200 Series

Replacement Parts

215RMAM, 230RMAM and 245RMAM

Hand Primer Pump Upgrade

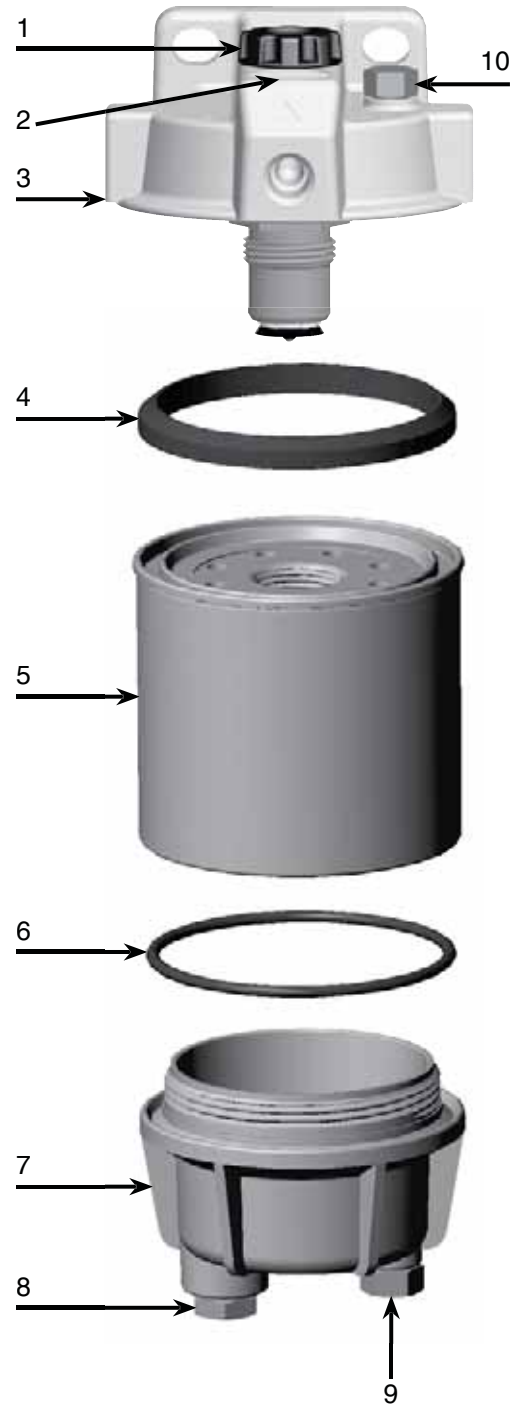
- Up to 37% increase in volume of fuel pumped per stroke
- Improved strength and alignment
- Improved ease of operation
- Reduced restriction in fuel flow
- Changeable in the field

This enhancement is possible by increasing the stroke length, by about 1/2", on the pump shaft and the element threaded adapter. Additionally, the knob and support ring have been redesigned to be more robust.

This change also affects replacement kits for the primer pump and head assemblies. The new style primer pump requires an additional 0.5 inch of space above the assembly (2 inches total) to utilize the added length of stroke; however, the primer pump will perform as always without any mounting modifications.

The new easy-grasp pump knob is larger than current knobs and the color will be changed from white to black to make a clear visual change between current pumps and newer versions.
